Service Bulletin

PRELIMINARY INFORMATION

Subject: Headlight Performance (BCM Calibration and Bulbs)

Models: 2015 GMC Sierra
2014 GMC Sierra 1500

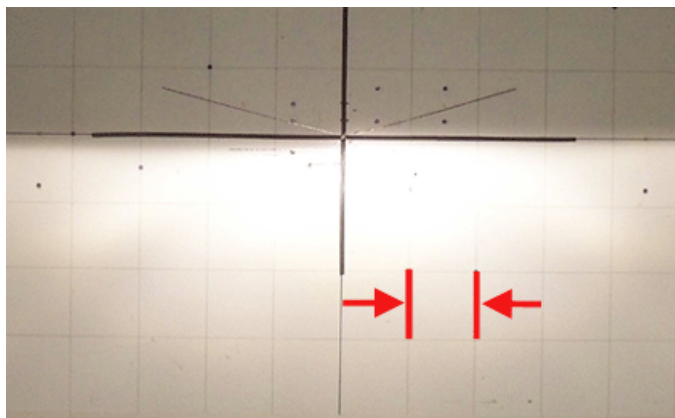
1. For vehicles built before 12/23/14 at Flint Assembly (11th Vin Digit "F"), 1/13/15 at Silao Assembly (11th Vin Digit "G") or 1/16/15 at Ft. Wayne Assembly (11th Vin Digit "Z"), reprogram the BCM with the latest calibration available in TIS2WEB starting on 1/12/2015. The new BCM calibration will increase the voltage to the headlight bulbs in both the low beam and high beam selections. All vehicle build after the above dates already have the new BCM calibrations and the BCM reprogramming does NOT need to be done.
2. Replace both headlight bulbs with updated bulb part number 23342527. IMPORTANT: Verify the correct bulb is being installed by confirming the following markings on the bulb:

1. 28432
2. HIR2+30

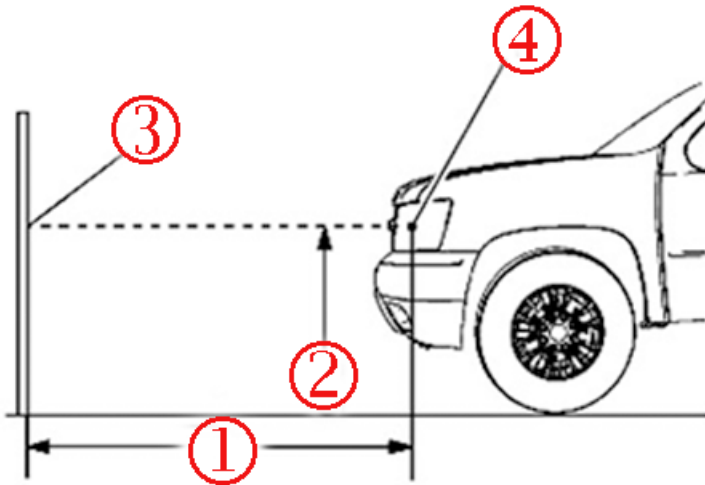
Important: When installing the new headlight bulbs, do not touch the glass and pay close attention that the bulbs are fully seated into the headlight housing. If the bulb is not properly installed it can lead to an incorrect light pattern. A beam pattern photo with a properly installed bulb is shown below. This photo is of a GMC Sierra Low beam pattern (1 Lamp with opposite lamp blocked) on wall/aiming screen at 25 ft (7.62 m). Each block division is approximately 10.5" (26.67cm)
